Access Compliance Report Public Rights-of-Way (Curb Ramps)

Main Street: WOODSONG		Cross Street: CASTLETREE		Location:	W
ADA ID: RPRK211018145314	Ramp Type:Type 1 - Perpendicular Diagonal Initial Pass/Fail: Fail		Overall Compliance: No	Severity Score:	15
Codes/Mitigation Info/Possible Solution			Field Measurements/Component Compliance

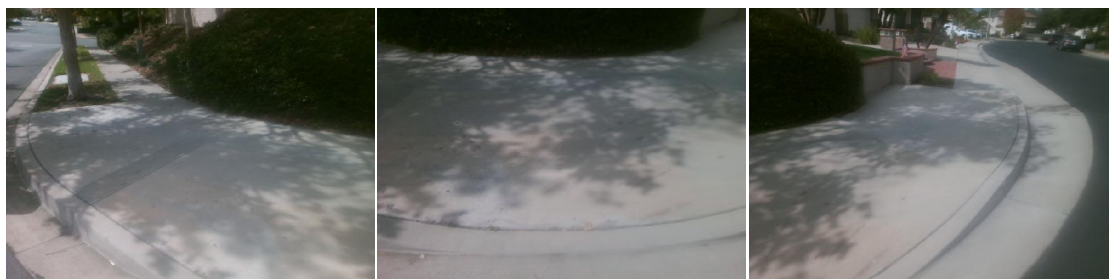
R204.3, R304.2.2, R302.7.2, STD 1115

Remove & Replace Curb Ramp With Two New Directional Ramps or Equivalent. Grind Gutter Lip.
